The Lantern / Stephenson House

Roof Terrace Design Development

The Lantern - Roof Terraces

Planning
 January 2022

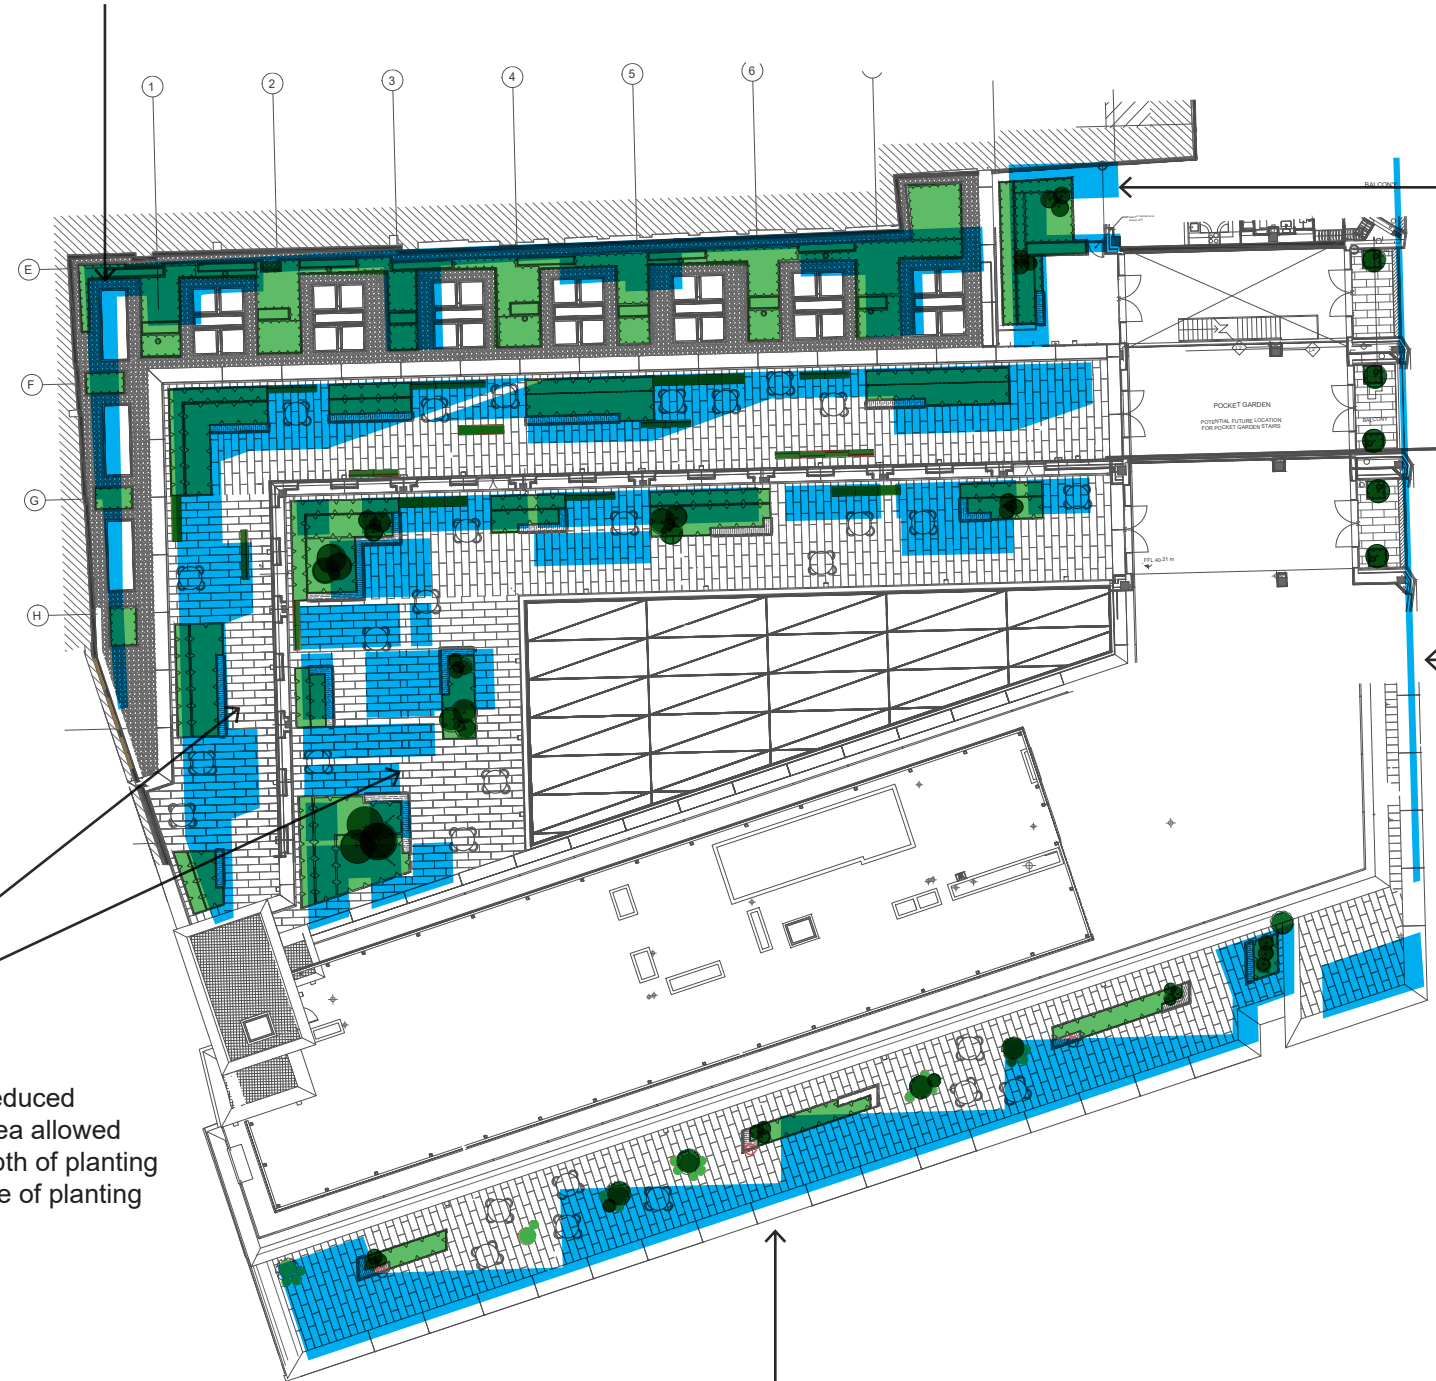
Level 1
 Roof lights changed in position and size, terrace no longer accessible for amenity use. Areas of synthetic turf replaced with planting resulting in no change in overall area of planting. Biodiversity panels added

Level 2
 Technical issues due to drainage, balustrade and paving / insulation design as well as development of glazing and access information led to changes in layout. Synthetic turf omitted.

Level 7
 Green roof strip omitted as technically unachievable once all the technical constraints had been understood.

Level 7
 Loading constraints as well as the position and height of the balustrade meant the area of planting to the amenity terrace to the 7th floor would be reduced significantly. As such the planting was omitted entirely

Levels 3 & 4
 Loading and technical issues reduced footprint of planters. Smaller area allowed localised areas with greater depth of planting substrate to support wider range of planting types.

Level 6
 Planting pulled away from terrace edge due to balustrade design. Planters located at centre of roof to suit loading and paving / insulation design constraints.
